ACCESSIBILITY ASSESSMENT

DATE OF REPORT:
March 4, 2025

ADA TITLE II ASSESSMENT

Guy Lee Elementary School
755 W Harlow Road
Springfield, Oregon 97477

Map for Barrier ID: AX545132

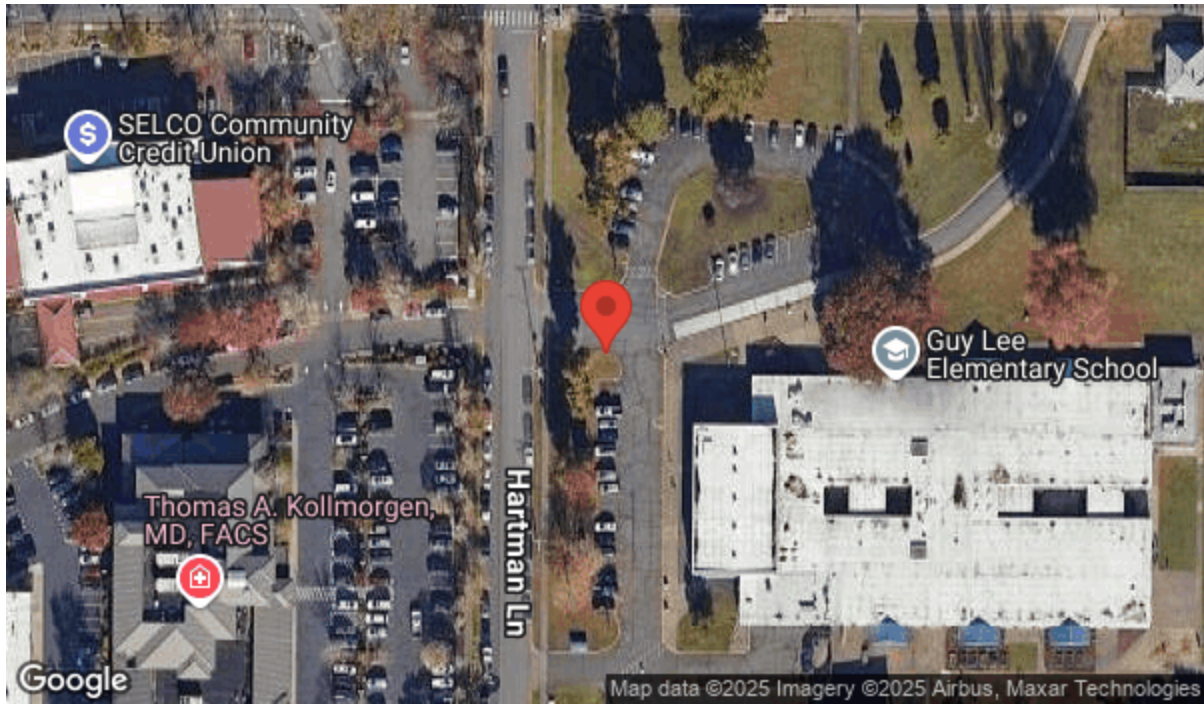
Assembly	Accessible Parking
Type	Parking Space - Van
ADA Standard	502.4
Barrier Detail	The access aisle slope is greater than 1:50 (2%).
Location Description	Access Aisle serving P1-A and P1-B
Observed	Jan 6, 2025 by Danjo.Ginete@bureauveritas.com
Site Conditions	The access aisle contains a slope of 2.9%.

Remove and replace with an adjacent access aisle that has a slope of maximum 1:50 (2%) in all directions. [EXCEPTION: Slopes not steeper than 1:48 (2.08%) shall be permitted.] Changes in level are not permitted. Parking spaces and access aisles serving them shall be compliant. Access aisles shall be at the same level as the parking spaces they serve. Measurements shall be made to the centerline of the stripe. Where accessible stalls and aisles are not adjacent to another stall or aisle, measurements shall be permitted to include the full width of the line defining the accessible parking space or aisle. The quantity and order of magnitude cost estimate provided for this barrier are limited to the extent of the area identified as non-compliant. Additional costs that may be associated with removal of the barrier are not included.

Map for Barrier ID: AX545128

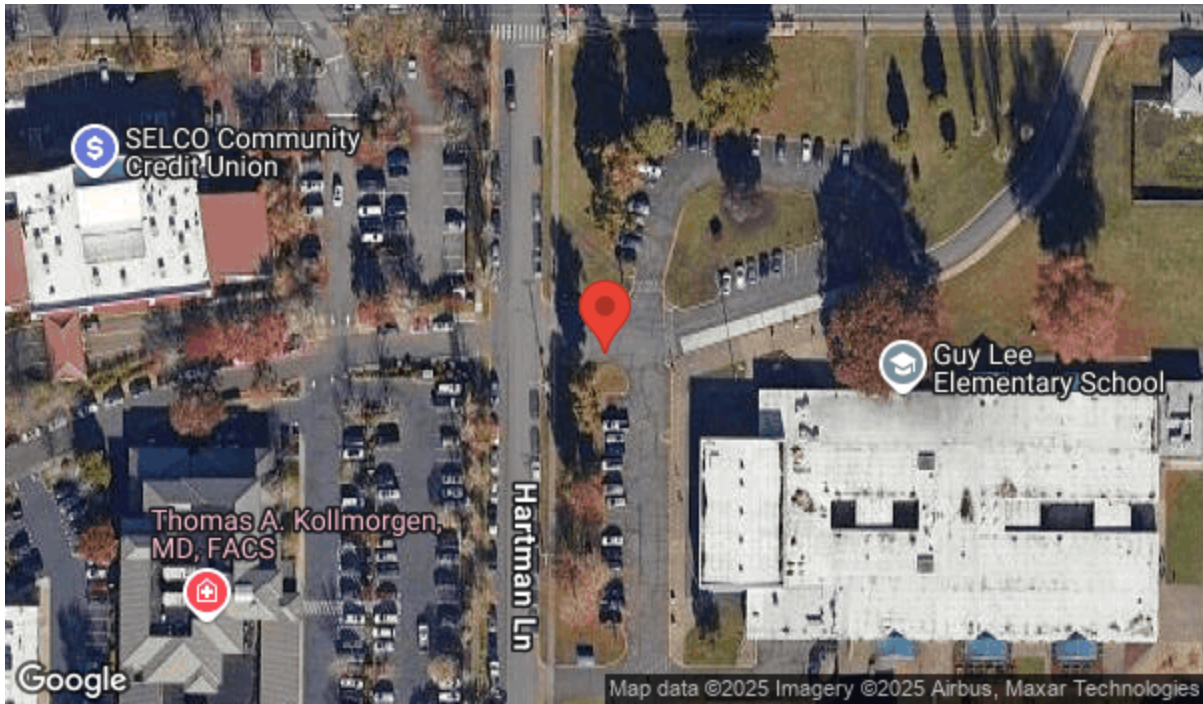
Assembly	Accessible Parking
Type	Parking Space - Van
ADA Standard	502.4
Barrier Detail	The parking space slope is greater than 1:50 (2%).
Location Description	Accessible Parking Space P1-A
Observed	Jan 6, 2025 by Danjo.Ginete@bureauveritas.com
Site Conditions	The accessible parking space has a slope of 8.4%.

Remove and replace with a van space which has a slope of maximum 1:50 (2%) in all directions. [EXCEPTION: Slopes not steeper than 1:48 (2.08%) shall be permitted.] Changes in level are not permitted. Parking spaces and access aisles serving them shall be compliant. Width measurements shall be made from the centerline of the markings. [EXCEPTION: Where parking spaces or access aisles are not adjacent to another parking space or access aisle, measurements shall be permitted to include the full width of the line defining the parking space or access aisle.] The quantity and order of magnitude cost estimate provided for this barrier are limited to the extent of the area identified as non-compliant. Additional costs that may be associated with removal of the barrier are not included.

Map for Barrier ID: AX545129

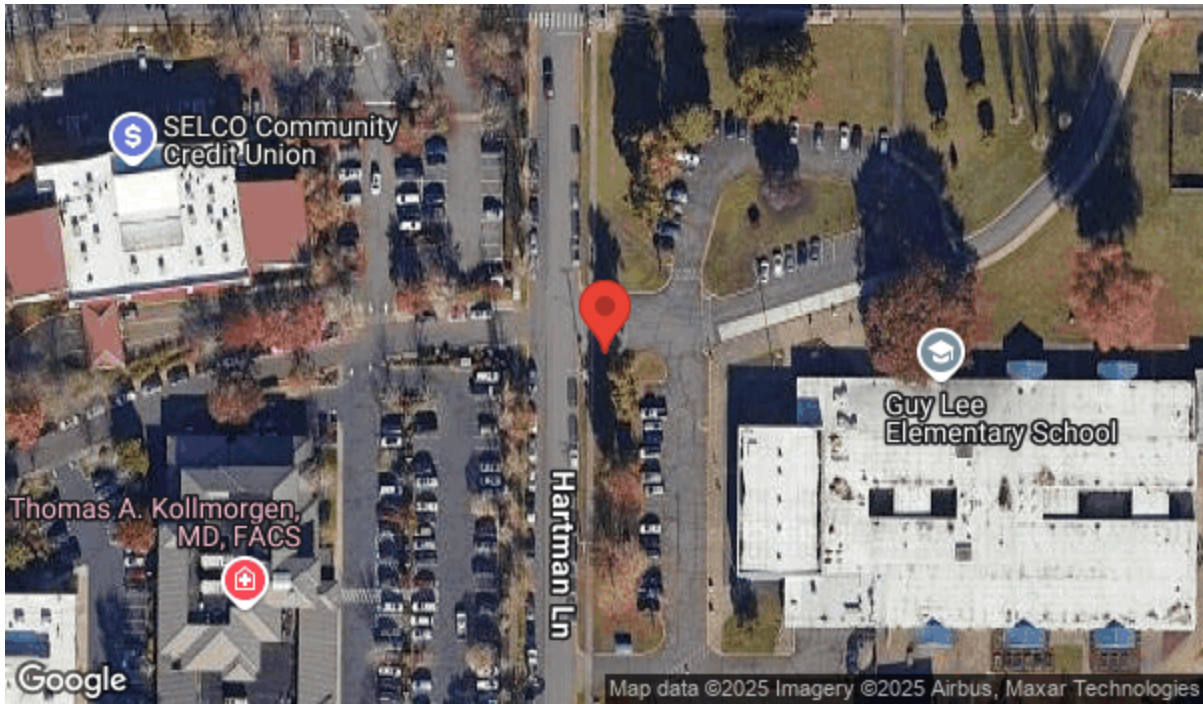
Assembly	Accessible Parking
Type	Parking Space - Van
ADA Standard	Oregon Revised Statutes 447.233-2(e) and 2(f); ADA 502.6
Barrier Detail	
OREGON: Signage and/or pavement markings is/are not compliant for the van accessible space.	
Location Description	Accessible Parking Space P1-A
Observed	Jan 6, 2025 by Danjo.Ginete@bureauveritas.com
Site Conditions	The bottom of the lowest sign is 63" above the parking surface.

Provide compliant signage and pavement markings for the van accessible stall. Install signage showing the International Symbol of Accessibility (ISA) EITHER on a free-standing post mounted minimum 84" (+ or - 3") above the stall surface measured to the bottom of the parking sign OR on a building or pier mounted minimum 60" above the stall surface measured to the bottom of the parking sign. Where signage is located on a free-standing post, the post shall be located at the head of the stall, and 2' minimum from the centerline of the painted lines outlining the sides of the stall. Parking space identification signs shall include the International Symbol of Accessibility. Signs identifying van accessible spaces shall contain the designation "van accessible". Where 5 or more accessible parking spaces are required, van stall signage shall designate one van accessible stall "wheelchair use only" in addition to "van accessible". Where the sign post is mounted on a raised surface which is higher than the stall pavement, the vertical measurement shall be from the stall pavement surface to the bottom of the sign. The International Symbol of Accessibility (ISA) shall be painted onto the pavement centered at the foot of the stall within the stall depth. Pavement lines shall be white 4" wide lines. Pavement markings and stencils are required to be white and should be retroreflective. The use of blue curb and blue background on pavement marking stencils is optional. Refer to the diagrams below.

Map for Barrier ID: AX545130

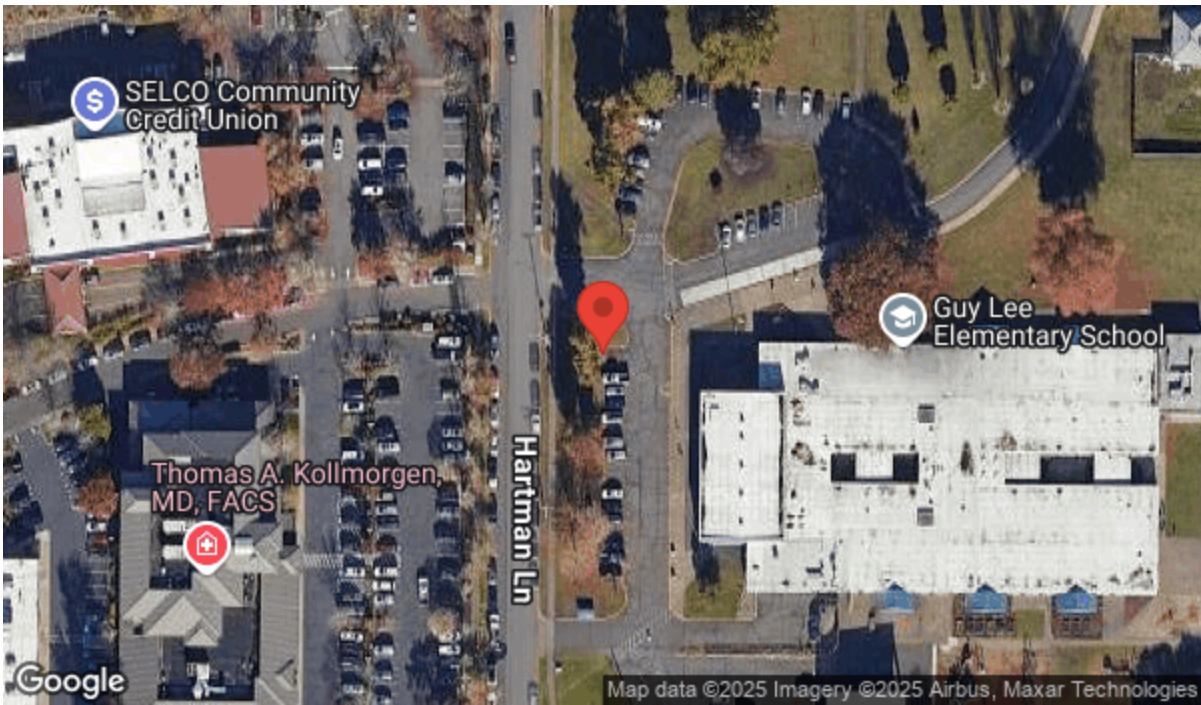
Assembly	Accessible Parking
Type	Parking Space - Van
ADA Standard	502.6
Barrier Detail	Compliant signage is not provided at the van stall.
Location Description	Accessible Parking Space P1-A
Observed	Jan 6, 2025 by Danjo.Ginete@bureauveritas.com
Site Conditions	The signage does not include the "van accessible" designation.

Provide a mounted sign for a van accessible stall which shall include the International Symbol of Accessibility and "van accessible" designation. The signage shall be mounted 60" minimum above the finish floor or ground surface measured to the bottom of the sign. Where the sign post is mounted on a raised surface which is higher than the stall pavement, the vertical measurement shall be from the stall pavement surface to the bottom of the sign.

Map for Barrier ID: AX545133

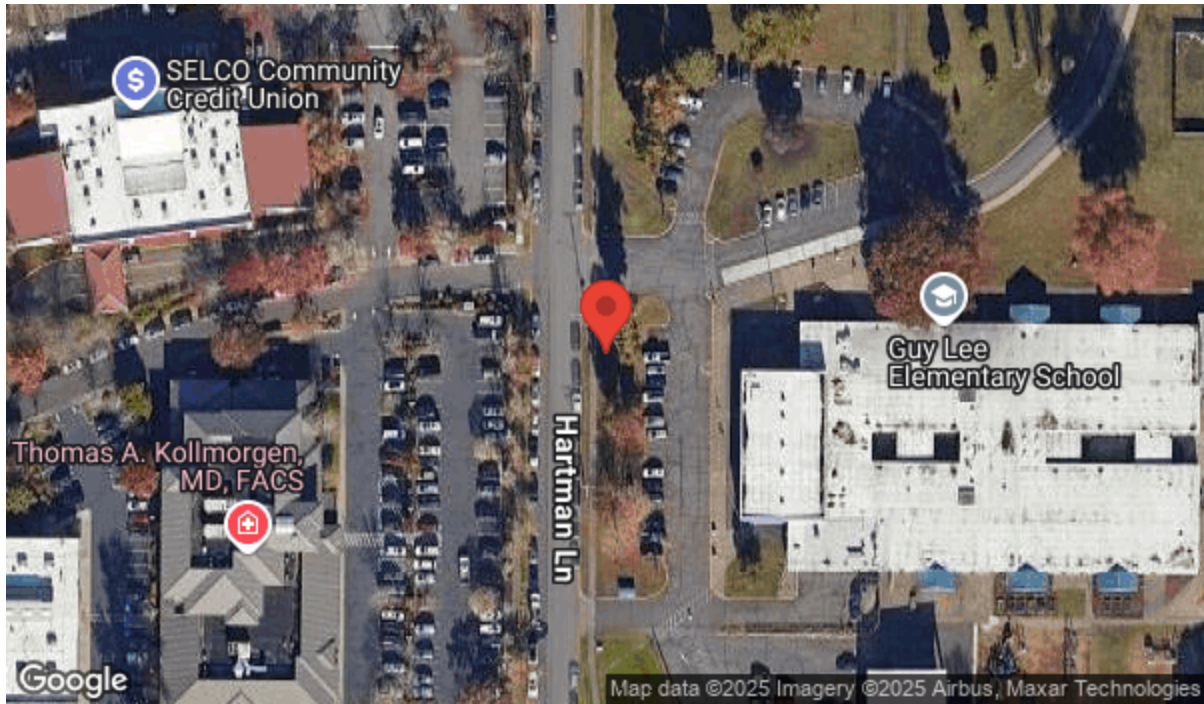
Assembly	Accessible Parking
Type	Parking Space - Car
ADA Standard	502.4
Barrier Detail	The slope of the parking space is greater than 1:50 (2%).
Location Description	Accessible Parking Space P1-B
Observed	Jan 6, 2025 by Danjo.Ginete@bureauveritas.com
Site Conditions	The accessible parking space has a slope of 4.4%.

Remove and replace with a parking space that has no more than 1:50 (2%) slope in all directions. [EXCEPTION: Slopes not steeper than 1:48 (2.08%) shall be permitted.] Changes in level are not permitted. Parking spaces and access aisles shall be level with surface slopes not exceeding 1:50 in all directions. Parking spaces and access aisles serving them shall be compliant. Access aisles shall be at the same level as the parking spaces they serve. The quantity and order of magnitude cost estimate provided for this barrier are limited to the extent of the area identified as non-compliant. Additional costs that may be associated with removal of the barrier are not included.

Map for Barrier ID: AX545135

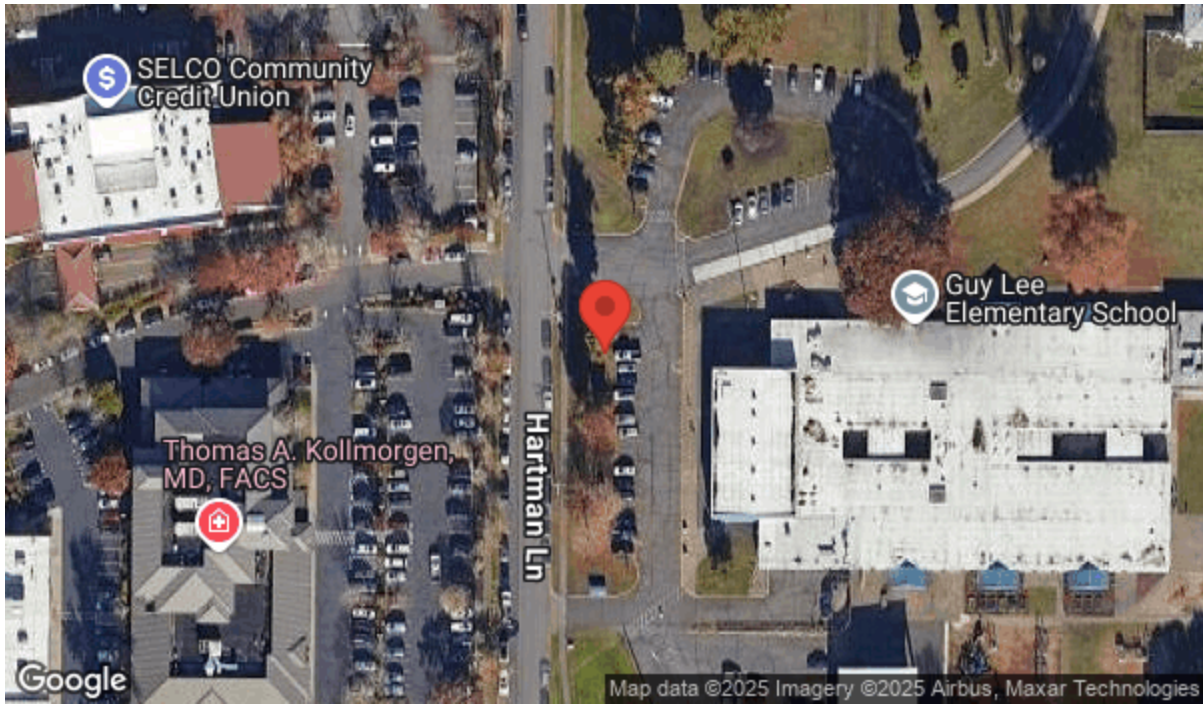
Assembly	Accessible Parking
Type	Parking Space - Car
ADA Standard	Oregon Revised Statutes 447.233-2(b) and 2(c); ADA 502.1
Barrier Detail	OREGON: The car accessible stall is less than 9' (108") wide.
Location Description	Accessible Parking Space P1-B
Observed	Jan 6, 2025 by Danjo.Ginete@bureauveritas.com
Site Conditions	The car accessible stall has a width of 106".

Provide a car stall minimum 9' (108") wide with adjacent access aisle minimum 6' (72") wide. The car stall shall be marked and access aisle shall be marked with painted lines 4" wide. Width measurements shall be made from the centerline of the markings. [EXCEPTION: Where parking spaces or access aisles are not adjacent to another parking space or access aisle, measurements shall be permitted to include the full width of the line defining the parking space or access aisle.] Each accessible parking space shall have a pavement marking of the International Symbol of Accessibility (ISA) centered at the entry to the stall and within the depth of the stall. Pavement markings and the ISA are required to be white and should be retroreflective. The use of blue curb and blue background on pavement marking for the ISA is optional. Refer to the diagrams below.

Map for Barrier ID: AX545118

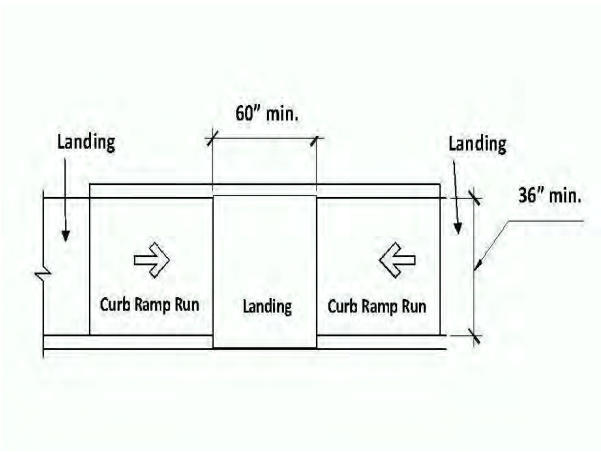
Assembly	Exterior Access Route
Type	Curb Ramp
ADA Standard	304, 406.4
Barrier Detail	The parallel curb ramp landing is not compliant.
Location Description	Curb Ramp CR-2
Observed	Jan 6, 2025 by Danjo.Ginete@bureauveritas.com
Site Conditions	The parallel curb ramp bottom landing is 48" width.
Bottom Landing Width	48"

Reconstruct the landings at the bottom and top of the parallel curb ramp. The bottom landing clear width shall be 60" minimum to allow for a 90 degree turn. The top landing clear width shall be at least as wide as the curb ramp run leading to the landing, and minimum 36" long. The slope of landings shall be maximum 1:48 (2.08%) in any direction.

Map for Barrier ID: AX545119

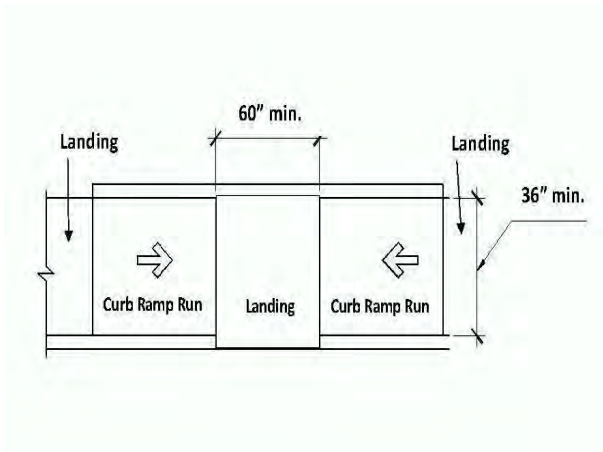
Assembly	Exterior Access Route
Type	Curb Ramp
ADA Standard	304, 406.4
Barrier Detail	The parallel curb ramp landing is not compliant.
Location Description	Curb Ramp CR-3
Observed	Jan 6, 2025 by Danjo.Ginete@bureauveritas.com
Site Conditions	The parallel curb ramp bottom landing is 38" width.
Bottom Landing Width	38"

Reconstruct the landings at the bottom and top of the parallel curb ramp. The bottom landing clear width shall be 60" minimum to allow for a 90 degree turn. The top landing clear width shall be at least as wide as the curb ramp run leading to the landing, and minimum 36" long. The slope of landings shall be maximum 1:48 (2.08%) in any direction.

Map for Barrier ID: AX545124

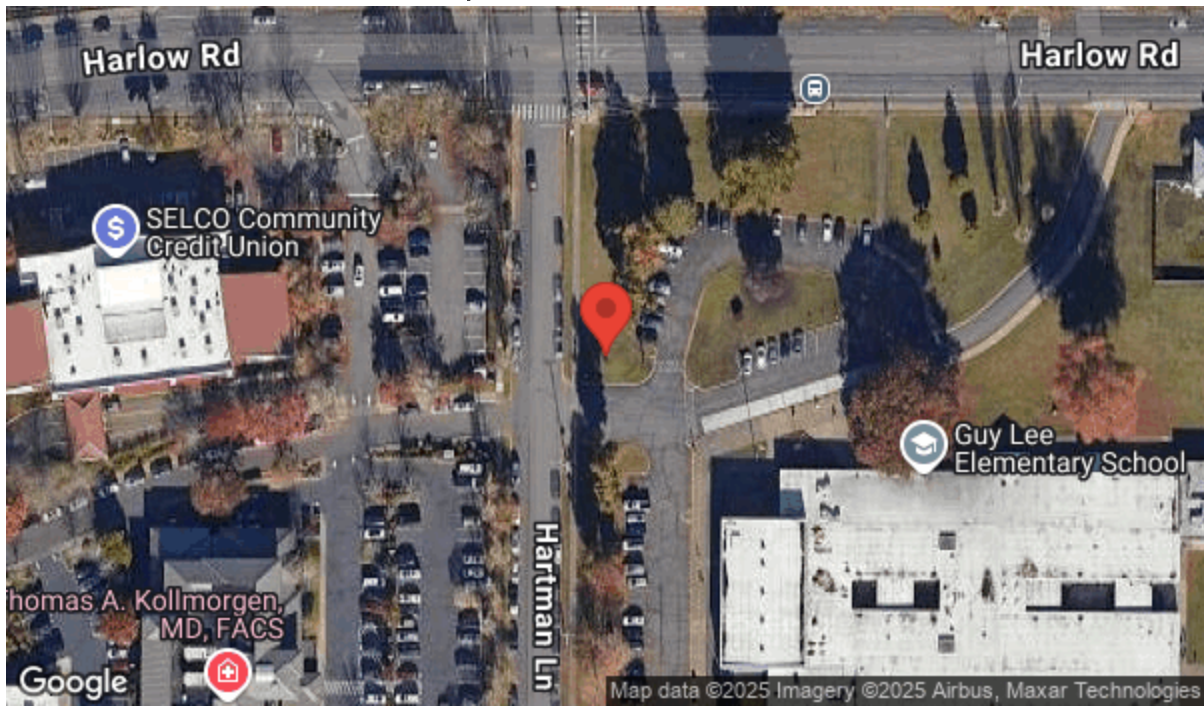
Assembly	Exterior Access Route
Type	Curb Ramp
ADA Standard	406.2
Barrier Detail	A curb ramp is not provided where the accessible route crosses a curb.
Location Description	Curb Ramp CR-7
Observed	Jan 6, 2025 by Danjo.Ginete@bureauveritas.com
Site Conditions	A curb ramp is not provided where the accessible route crosses a curb.

Install a compliant curb ramp. Compliant curb ramps shall be provided wherever an accessible route crosses a curb. Curb ramp runs shall have a running slope not steeper than 1:12. Cross slope of ramp runs shall not be steeper than 1:48. The running slope in new construction shall be 1:12 maximum. [EXCEPTION: In existing sites, buildings, and facilities built before 1/26/92, ramps shall be permitted to have running slopes steeper than 1:12 where such slopes are necessary due to space limitations. The running slope can be 1:10 to 1:8 (10% to 12.5%) for a maximum rise of 3" OR 1:10 to 1:12 (8.3% to 10%) for a maximum rise of 6".] Where provided, flare slopes shall be maximum 1:10 (10%). Provide a landing at the top of the curb ramp. The landing clear length shall be 36" minimum. The landing clear width shall be minimum 48" wide, and at least as wide as the curb ramp, excluding flared sides. Changes in level are not permitted. Slopes not steeper than 1:48 shall be permitted.

Map for Barrier ID: AX545147

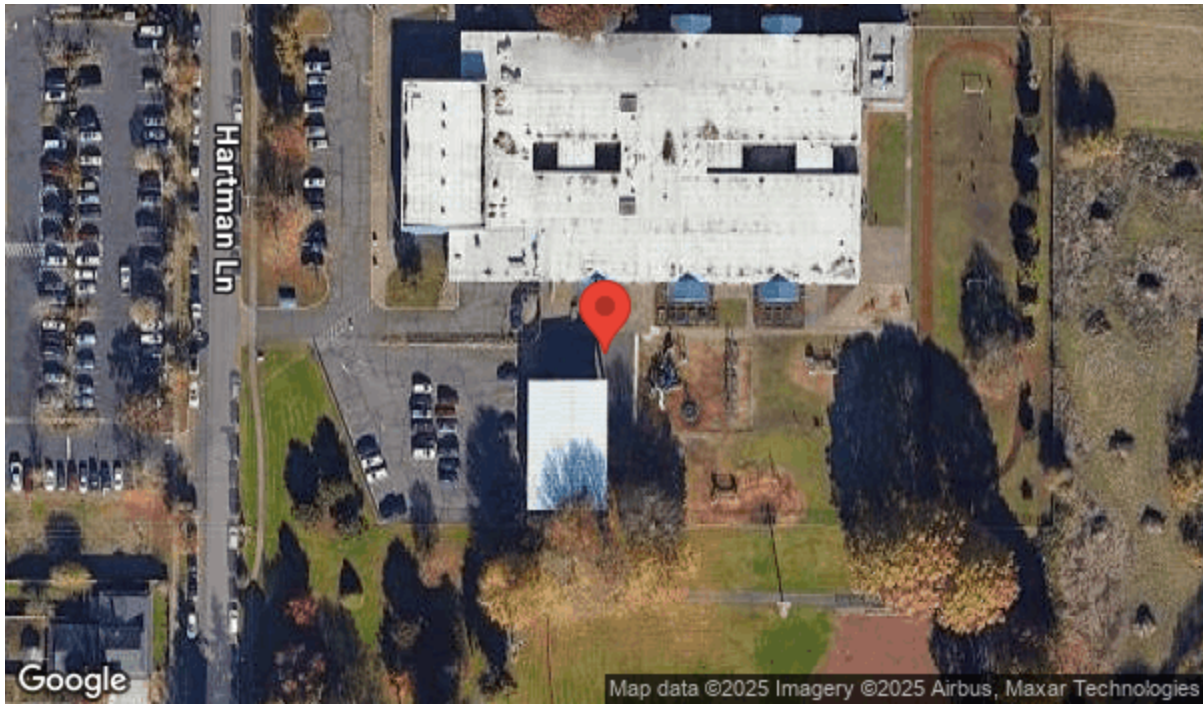
Assembly	Exterior Access Route
Type	Curb Ramp
ADA Standard	405.2; Table 405.2; 406; 406.2
Barrier Detail	The curb ramp does not meet the slope requirements.
Location Description	Curb Ramp CR-9
Observed	Jan 6, 2025 by Danjo.Ginete@bureauveritas.com
Site Conditions	The curb ramp has a running slope of 9.2%.
Highest Running Slope	9.2%

The curb ramp should be removed and replaced with a compliant curb ramp with no greater than the maximum allowable slopes of a ramp. Curb ramp runs shall have a running slope not steeper than 1:12 (8.33%). Cross slope of curb ramp runs shall not be steeper than 1:48. The running slope in new construction shall be 1:12 (8.33%) maximum. [EXCEPTION: In existing sites, buildings, and facilities built before 1/26/92, ramps and curb ramps shall be permitted to have running slopes steeper than 1:12 where such slopes are necessary due to space limitations. In facilities built before 1/26/92, the running slope can be 1:10 to 1:8 (10% to 12.5%) for a maximum rise of 3" OR 1:10 to 1:12 (8.3% to 10%) for a maximum rise of 6".] Where flares are provided, flare slopes shall not be greater than 1:10 (10%). [EXCEPTION: In alterations, where there is no landing at the top of curb ramps, curb ramp flares shall be provided and shall not be steeper than 1:12.]
